ABC COMPANIES
Exclusive U.S. VANHOOL Distributor

TECH TIPS
#1104

COACH MODEL :	C2045 & T2100
DATE :	02/03/2011
SUBJECT :	HVAC Check Valve Change

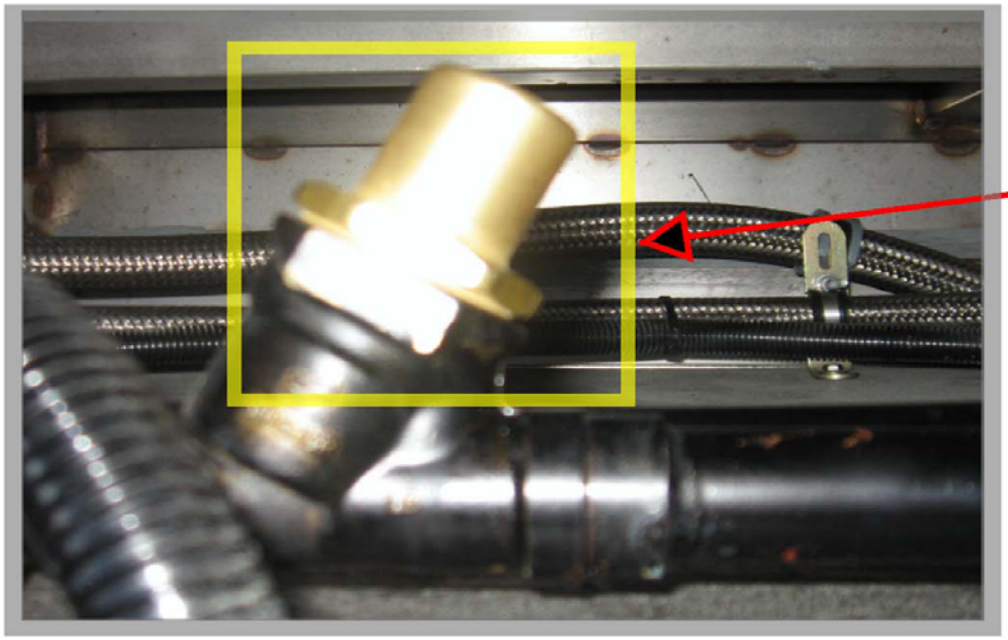
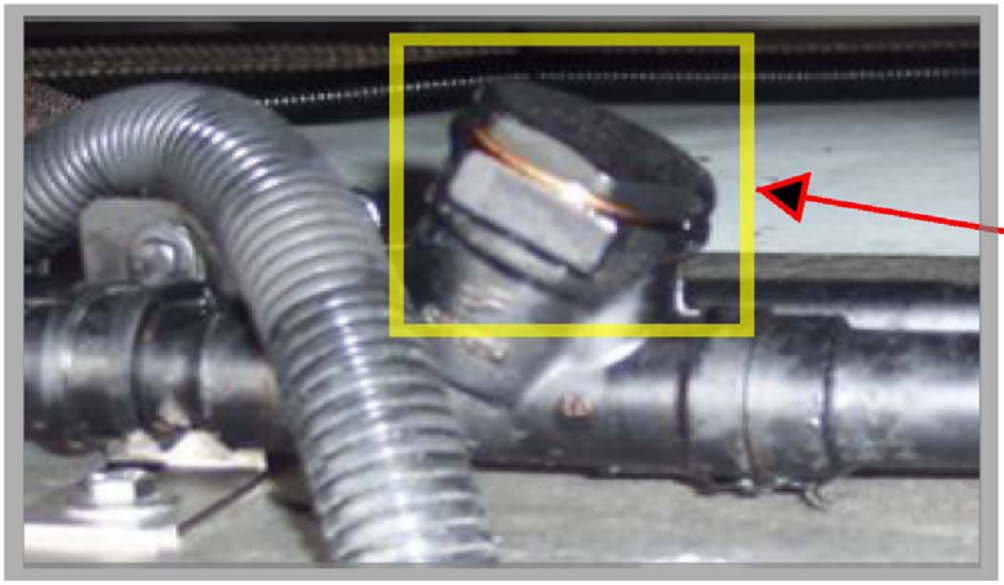
You can ID the new style check valve with the raised center on the cap

The old style has the flat cap

It has been noticed when a C or T coach is in A/C mode and the engine is at regular idle RPM's that the check valve behind the condenser may make a knocking noise. Check the system to verify the correct operating pressures and refrigerant level is ok. If noise still continues ,replacement of the check valve will be necessary

NEW
Part numbers
VH # 11184588
or Carrier #
14-00281-04
